**PLANNING COMMISSION  
THURSDAY, AUGUST 5, 2021 6:00 PM**

1. Application #2021-5348; PID 067-000086; Eric Elizondo (Skilken Gold); Major Site Plan (Sheetz)
2. Application #2021-5350; PID 060-004558-00; John Spagnolo; Final Plat (Rose Hill Townhome Development)

# MAJOR SITE PLAN

RE: Sheetz – Major Site Plan #2021-5348 Staff Report

| DESCRIPTION                                                                                            |  | BY | DATE | NO. |
|--------------------------------------------------------------------------------------------------------|--|----|------|-----|
| C200                                                                                                   |  |    |      |     |

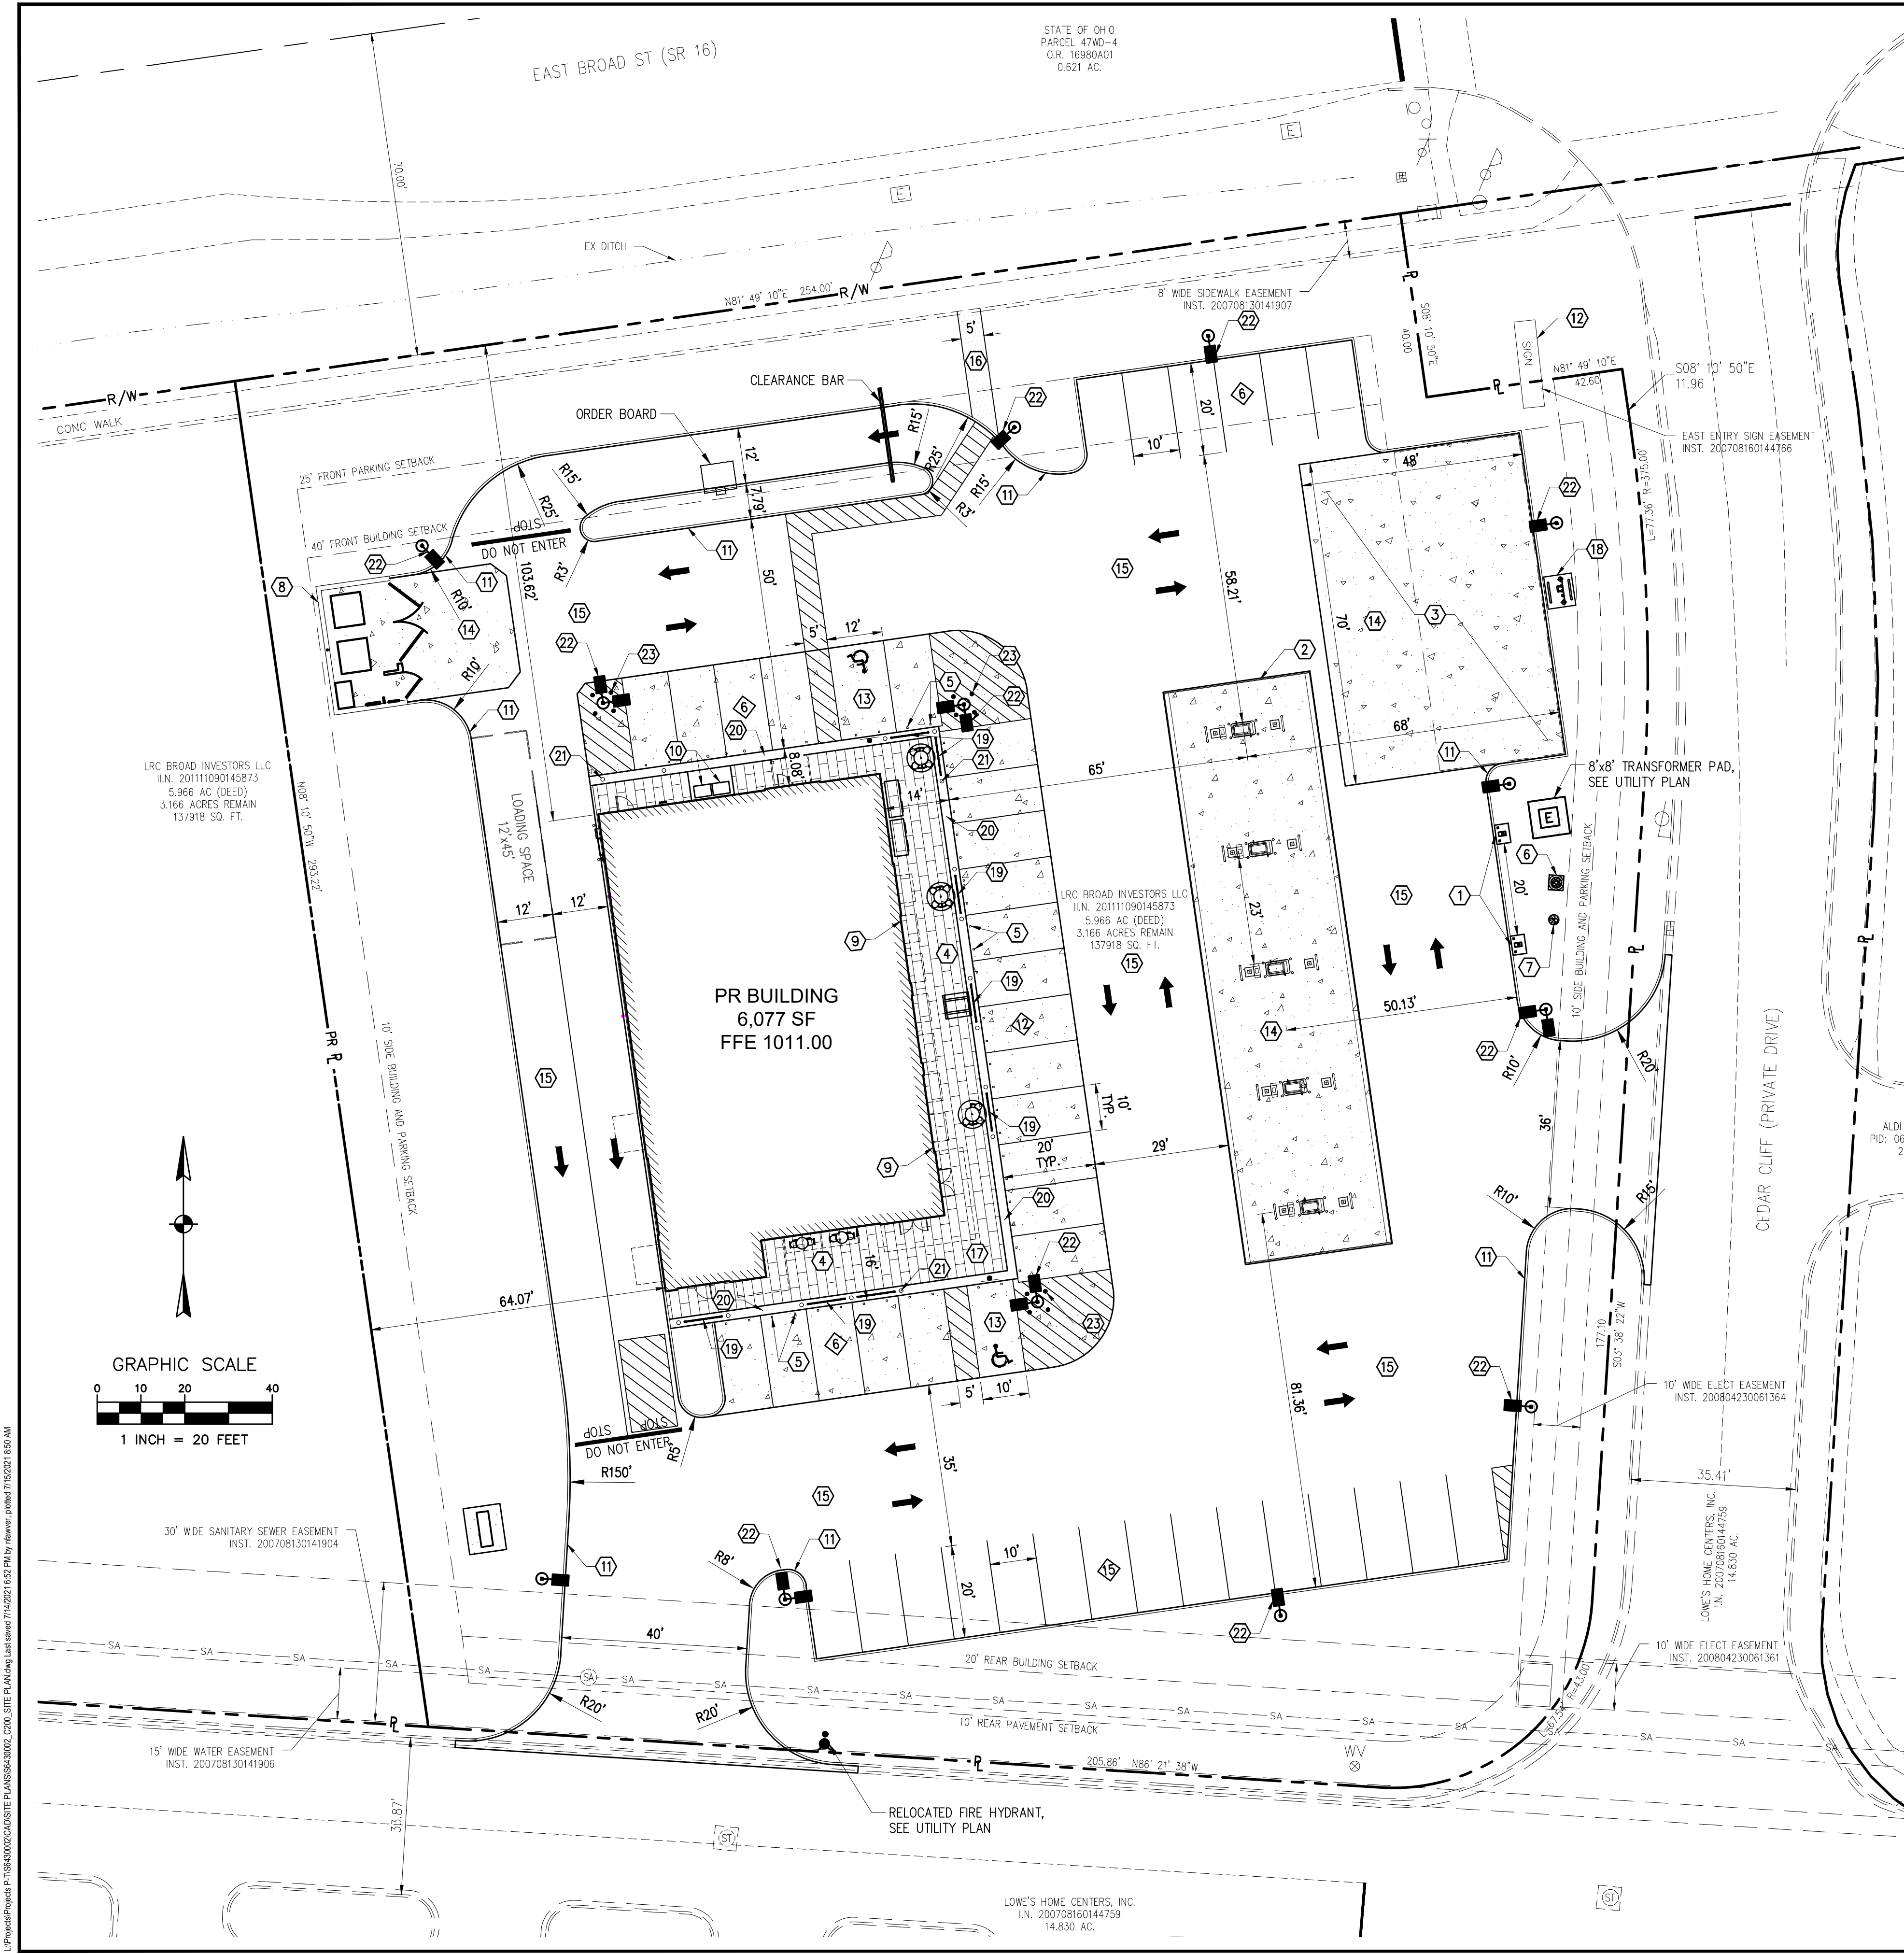
1. The Chase Bank, AutoZone, Tire Discounters and Valvoline sites to the west are connected via cross access drives. Is there a desire by the City to provide a drive stub for a future connection when the property to the west develops? If so, it seems to be best located where the dumpster is currently shown. The dumpster could potentially relocate to the southwest corner of the site, and this would also allow for the dumpster to not be adjacent to East Broad Street.

2. The site is providing two access points; one onto Cedar Cliff across from the Aldi entrance and one to the south onto an existing access drive.
3. The south drive has a width of 40' which exceeds the maximum width of 36' as shown in Reynoldsburg Standard Drawing R-12. Please provide justification to exceed the maximum width of 36'.

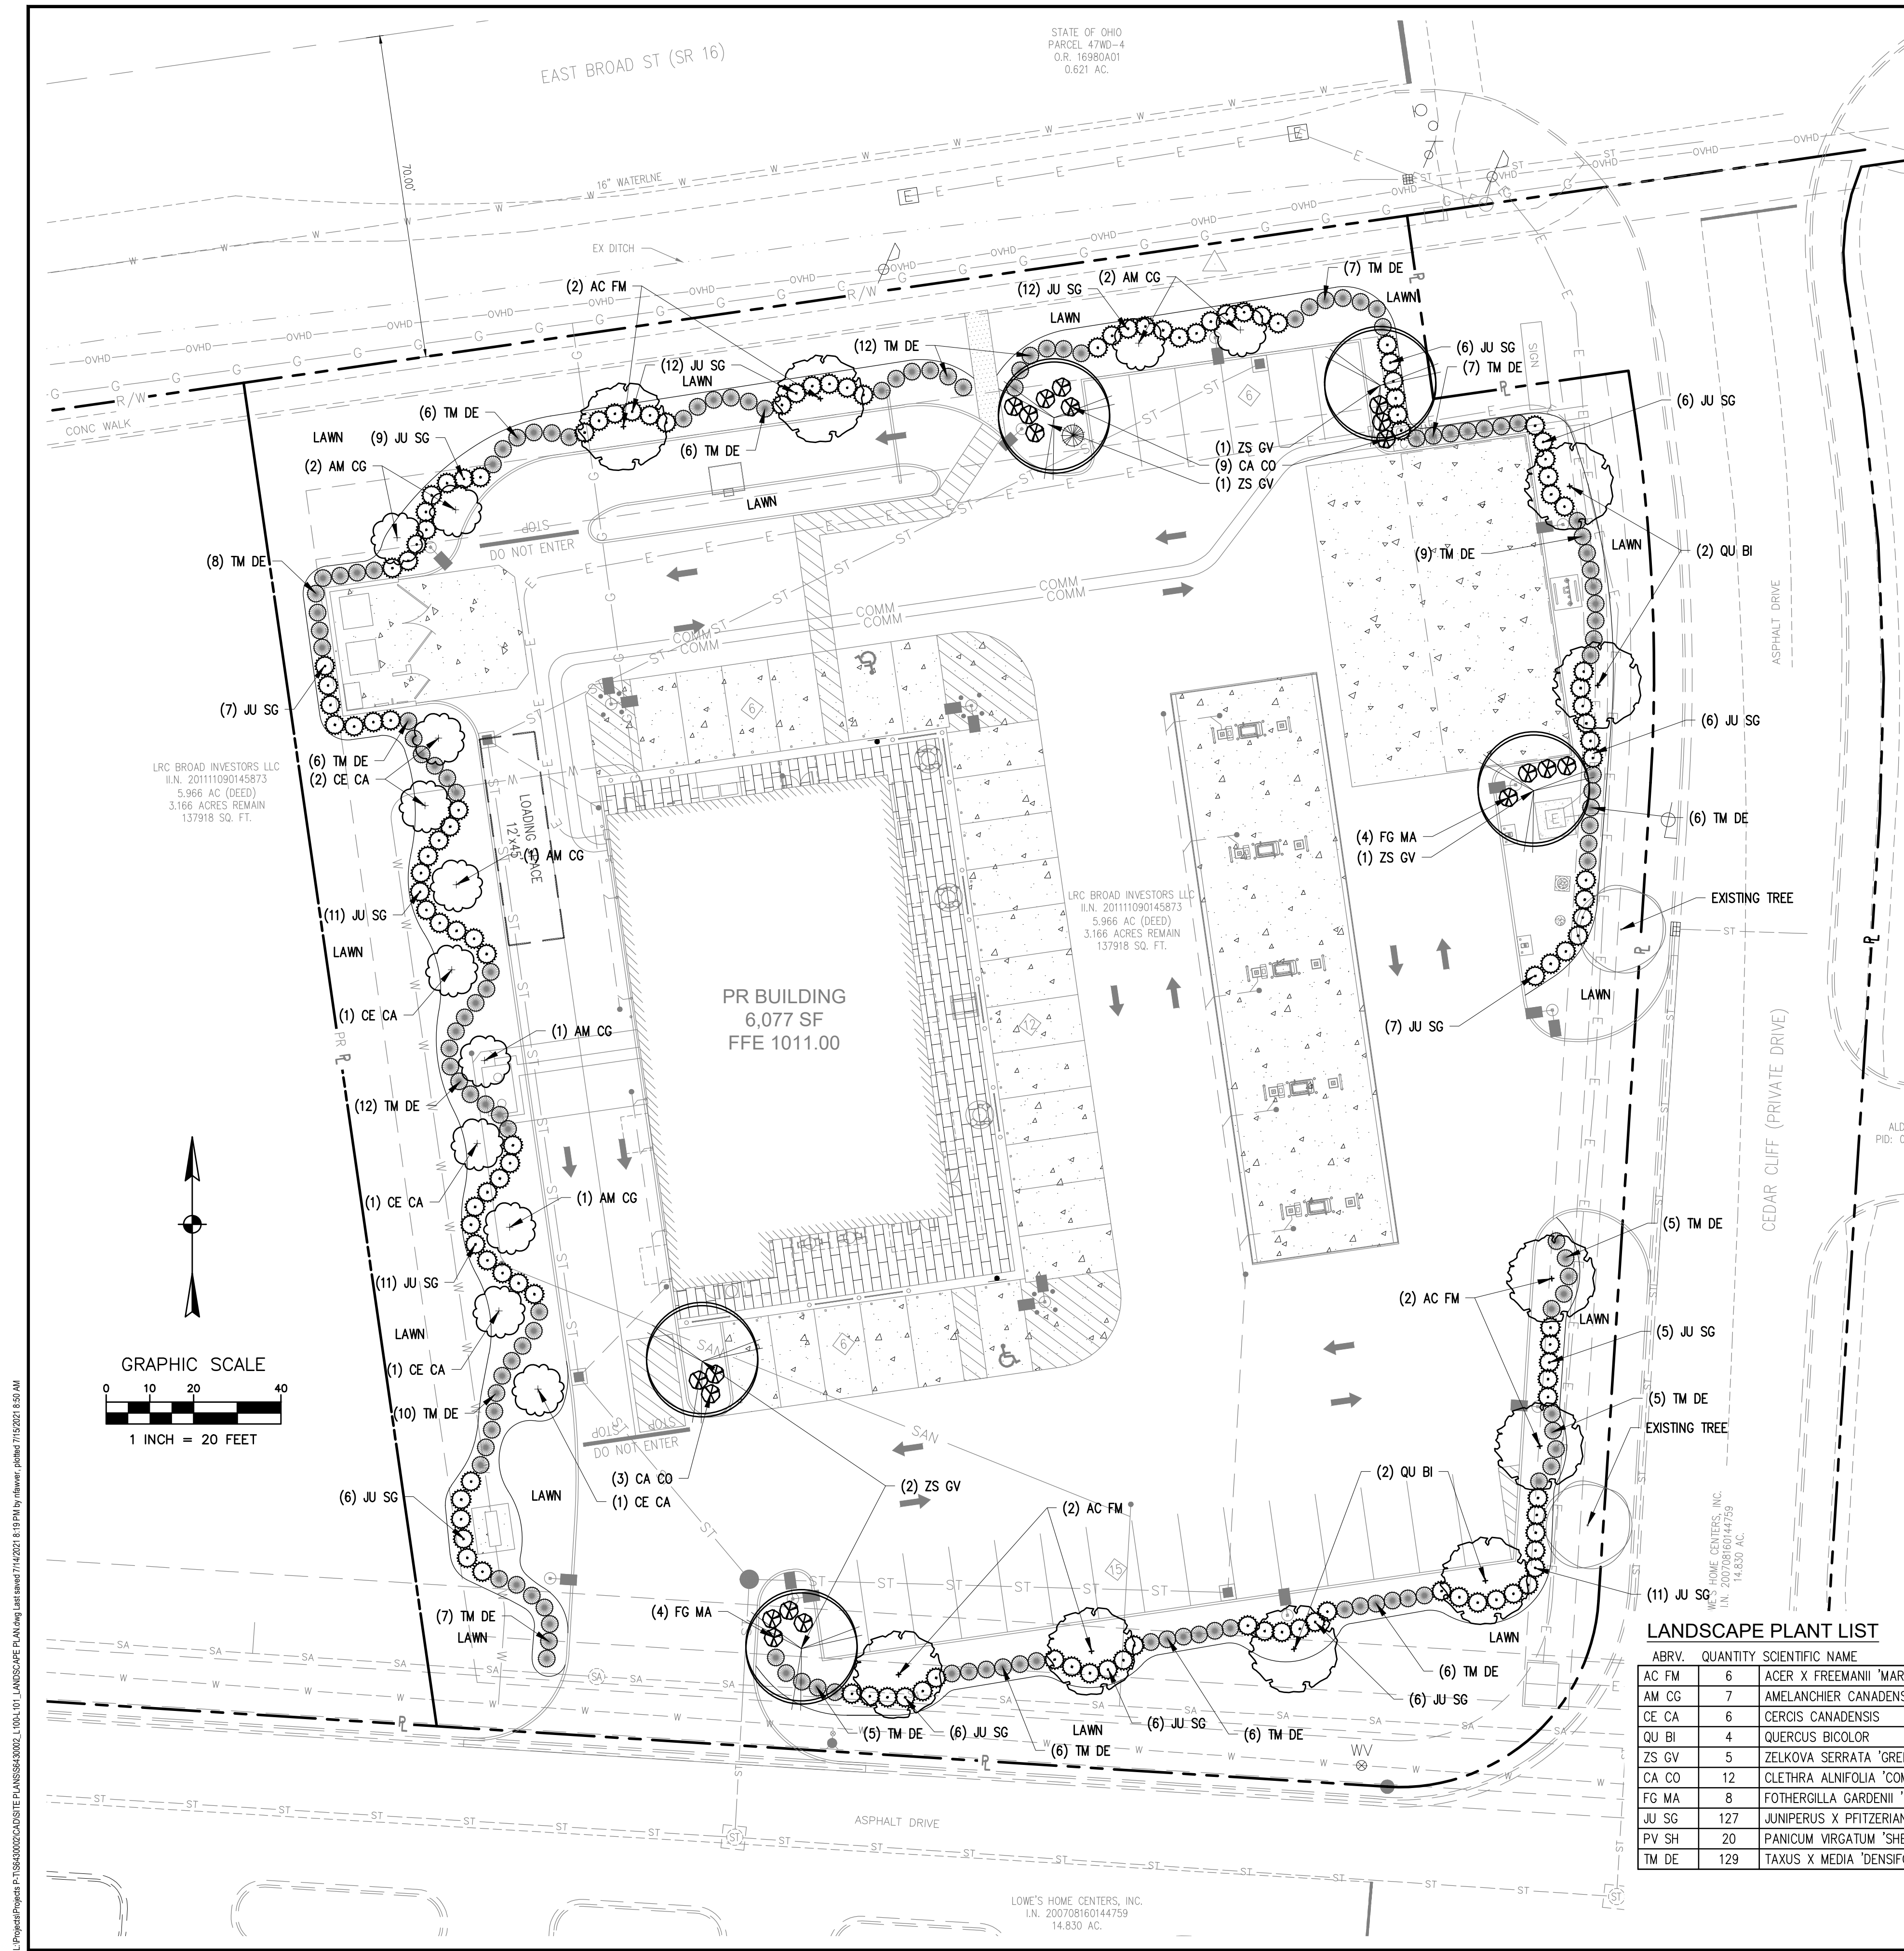
6. For the proposed water service tap and meter, please review and reference the applicable Reynoldsburg Standard Drawings with the PGU submission.
7. The proposed fire hydrant relocation shall be per Reynoldsburg Standard Drawing W-14. Columbus standards are not needed.
8. With PGU submittal, provide labels and plan numbers for the existing watermain, sanitary sewer and storm sewer.
9. Please show that the drainage under the fuel canopy will be routed to an oil/water separator and into the sanitary system.
10. For lighting, the site is utilizing various styles of lights including light poles for the drives and parking areas, lighted bollards and wall mounted lights for pedestrian areas adjacent to the
